ECE/TRANS/WP.29/GRE/2006/43
21 July 2006

PROPOSAL FOR DRAFT AMENDMENTS TO REGULATION No. 98

(Headlamps with gas-discharge light sources)

Submitted by the expert from the Working Party "Brussels 1952" (GTB)

Annex 4 - Appendix, amend to read:

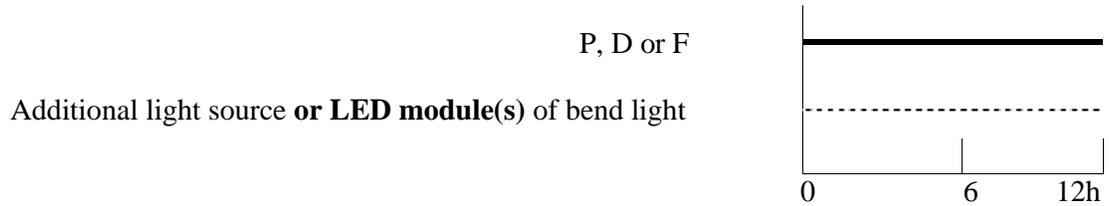
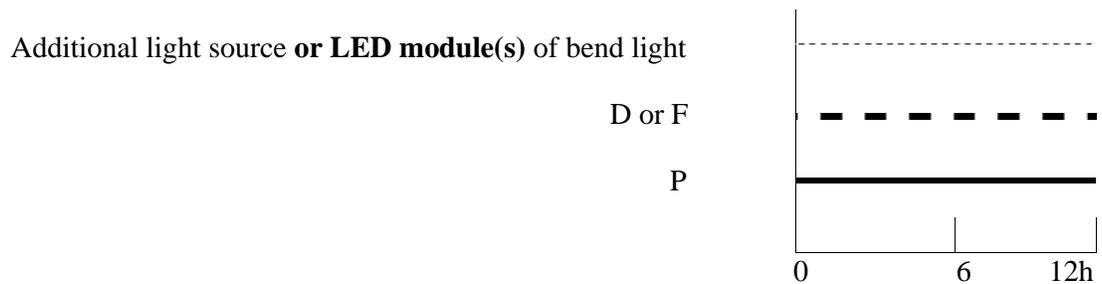
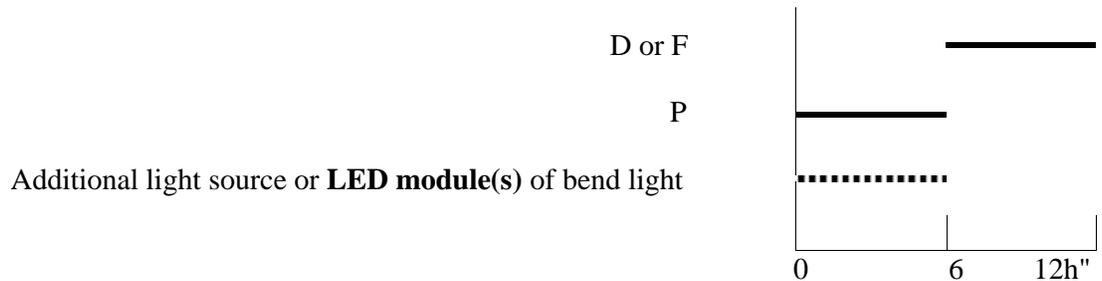
OVERVIEW OF OPERATIONAL PERIODS
CONCERNING TEST FOR STABILITY OF PHOTOMETRIC PERFORMANCE
